**106 वीं पीसीसी बैठक
का
कार्यवृत्त
Minutes
of
106th PCC Meeting**

EASTERN REGIONAL POWER COMMITTEE

MINUTES OF 106TH PROTECTION COORDINATION SUB-COMMITTEE MEETING HELD ON 16.09.2021 AT 10:30 HOURS

PMU plot of Subhasgram Bus-Voltage showing Fault clearance 350 ms zone-2 time from WB end.

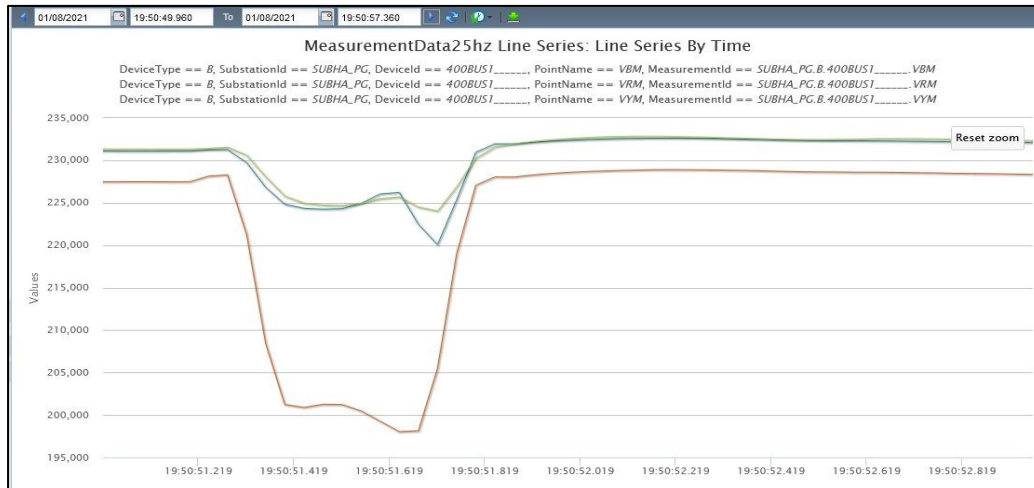
end which would have avoided delayed clearance second time and Cesc Islanding.(WBSETCL to update).

- But prior to that Islanding condition -2 got satisfied as it considers delay of only 150 ms and CESC islanded again.(Logic shown below)
- Rest 132 kV KASBA WBSETCL system was healthy and intact this time.

SCADA plot for EVENT 1: BugBug generation Vs CESC frequency vs Grid Frequency

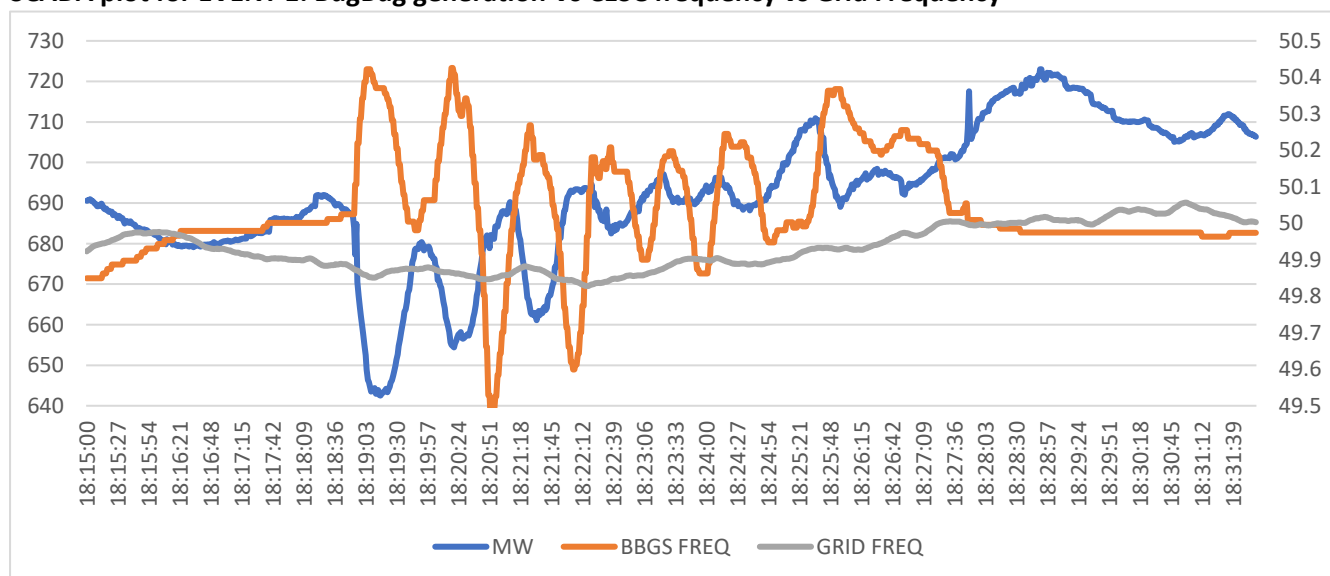
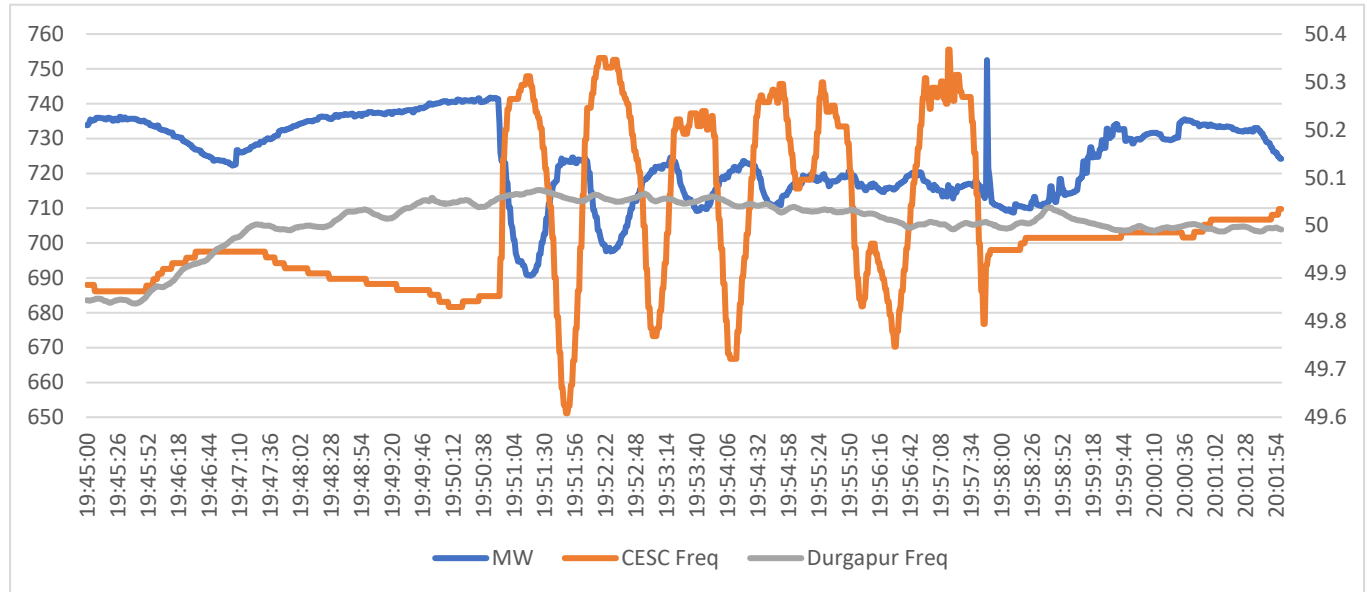
Observations During Islanding of CESC:

Reason for such continuous high oscillating variation in frequency may be analysed and possible consequences may also be looked into as it may cause operation of UFR relay in some cases inside the island.
